ITEM: 6.11	COMMITTEE OF ADJUSTMENT REPORT SUMMARY MINOR VARIANCE APPLICATION FILE NUMBER A275/22 165 PURPLE CREEK ROAD, WOODBRIDGE
-------------------	--

**COMMITTEE OF ADJUSTMENT REPORT
MINOR VARIANCE APPLICATION
A275/22
165 PURPLE CREEK ROAD, WOODBRIDGE**

ITEM NUMBER: 6.11	CITY WARD #: 3
APPLICANT:	Matteo & Gianna Genova
AGENT:	Andrew Solari
PROPERTY:	165 Purple Creek Rd Woodbridge ON L4H 5C6
ZONING DESIGNATION:	See below
VAUGHAN OFFICIAL PLAN (2010) DESIGNATION:	City of Vaughan Official Plan 2010 ('VOP 2010'): "Low Density Residential," Volume 2, Section 12.13 Block 40/47
RELATED DEVELOPMENT APPLICATIONS:	None
PURPOSE OF APPLICATION:	Relief from the Zoning By-law is being requested to permit a proposed pool and installation of related (pool) equipment.

FLOATING CONCRETE SLAB TYP. DETAIL
SCALE: NTS

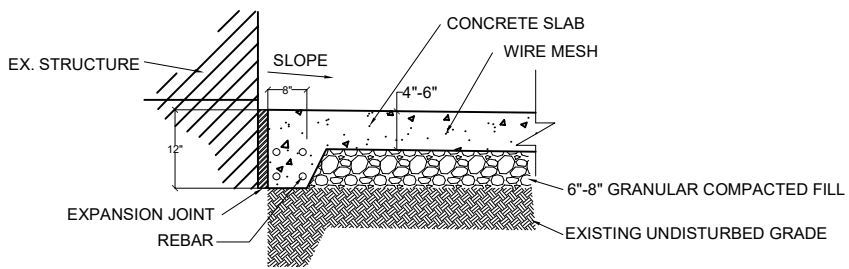
The Applicant has implemented a floating concrete slab design in order to ensure that drainage on the side yard swale is not impacted.
